Product Change Notification (PCN)

PCN #: 12C-2024

Ezurio Part Number	Description
453-00059R	Module, BL653μ, Integrated Antenna, Tape and Reel
453-00059C	Module, BL653μ, Integrated Antenna, Cut Tape
453-00060R	Module, BL653μ, RF Trace Pin, Tape and Reel
453-00060C	Module, BL653μ, RF Trace Pin, Cut Tape

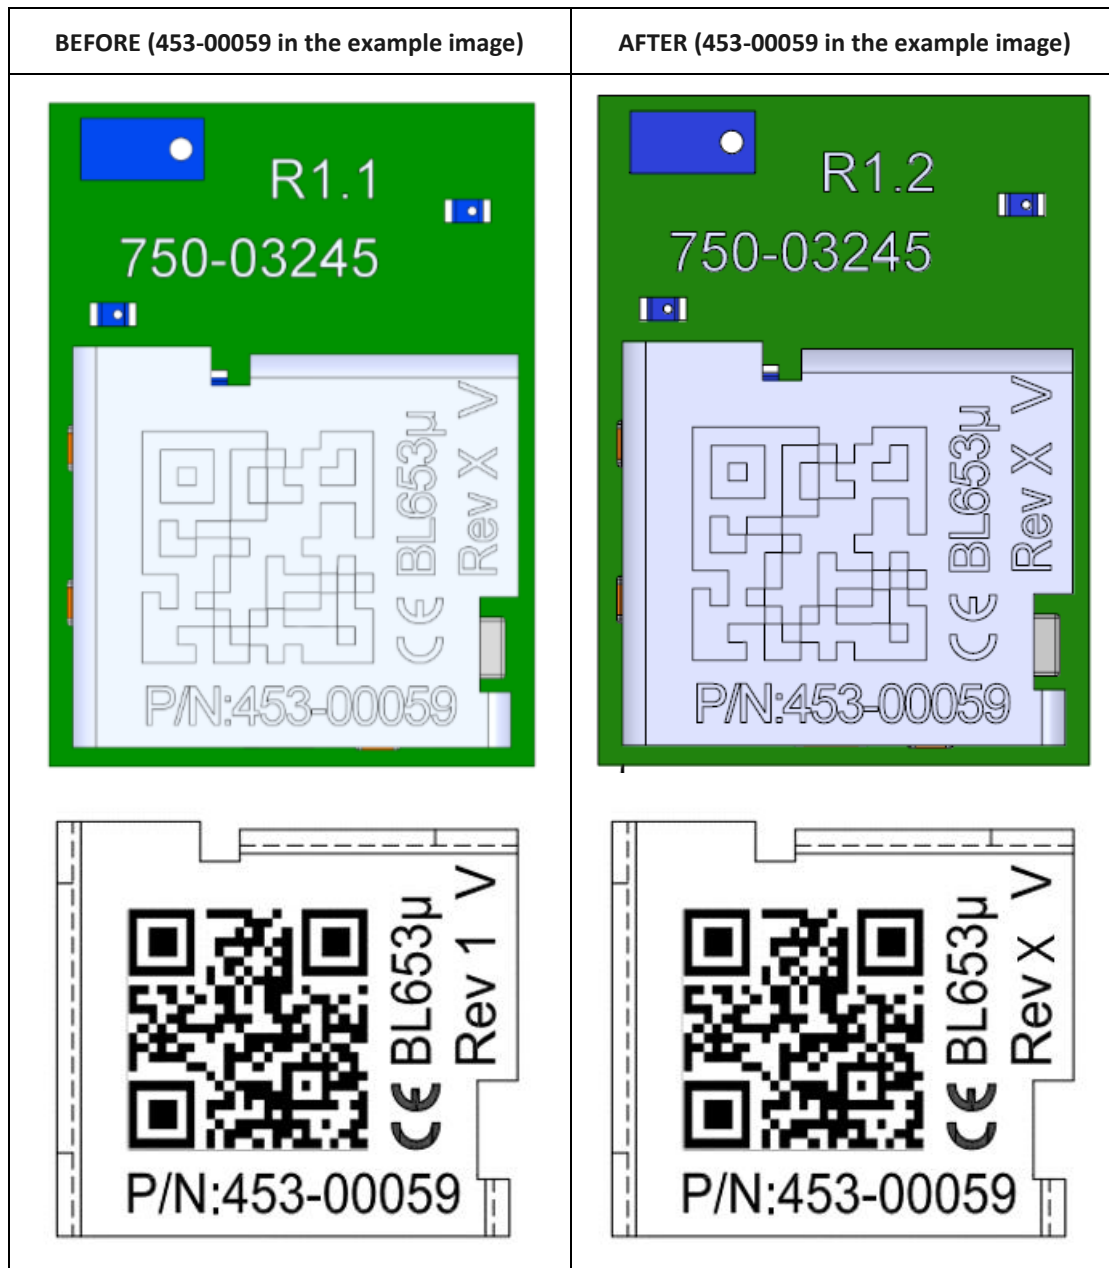
- **453-00059R/453-00059C/453-00060R/453-00060C**
 - On the PCB, update revision silkscreen from R1.1 to R1.2
 - On the device laser-etching:
 - Update product revision from Rev 1 to Rev 2. Rev X in the AFTER example image below is a variable subject to change based on the hardware revision.
 - Add V, indicating the Country of Origin.

- On the reel and bag labels:

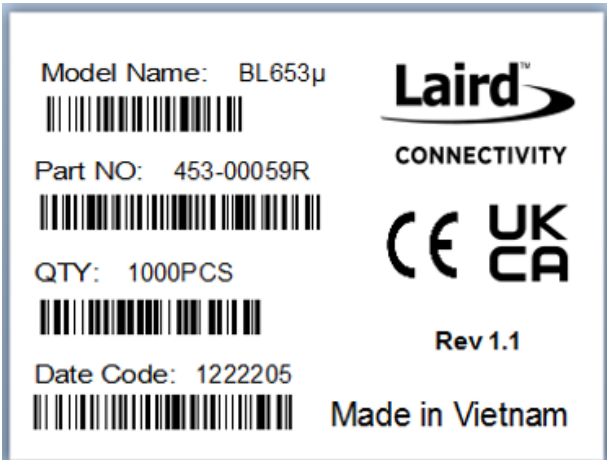
- Update product revision from Rev 1 to Rev 2. Rev X in the AFTER example image below is a variable subject to change based on the hardware revision.
